# Venice, Florida

# ZONING AMENDMENT STAFF REPORT RAMSEY ROAD PUD AMENDMENT

**PETITION NO.:** 19-04RZ

#### Development Standards: Approved PUD vs. Proposed PUD

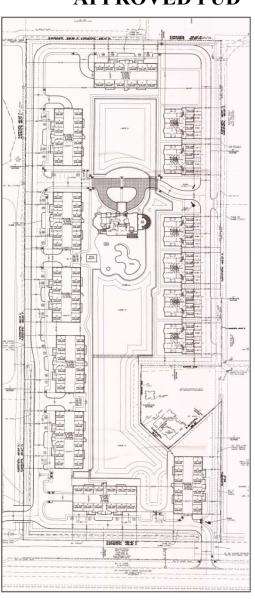
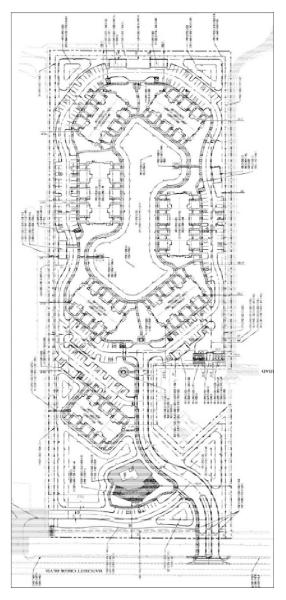
The applicant has submitted an application to amend the current zoning of the PUD zoned subject property with a revised binding master plan to provide for a similar project as previously approved. The zoning map will not change, only the associated PUD binding master plan will be revised. Provided in the table above are the development parameters for both the originally approved PUD project that was never constructed and the proposed PUD zoned project. Differences, as you can see, are minimal and mainly show up in the perimeter setbacks. These differences are due to the proposed projects provision of detached garage parking and the previous projects inclusion of understory parking. This difference has resulted in a lower proposed building height even though the permitted height is the same. The previous understory parking was exempt from building height per an allowance in the PUD code. Other differences occur in the proposed projects increased landscape buffer width and percentage of open space. There is also a reduction in the unit count of four units. Other than these differences, the projects are similar in scope and nature.
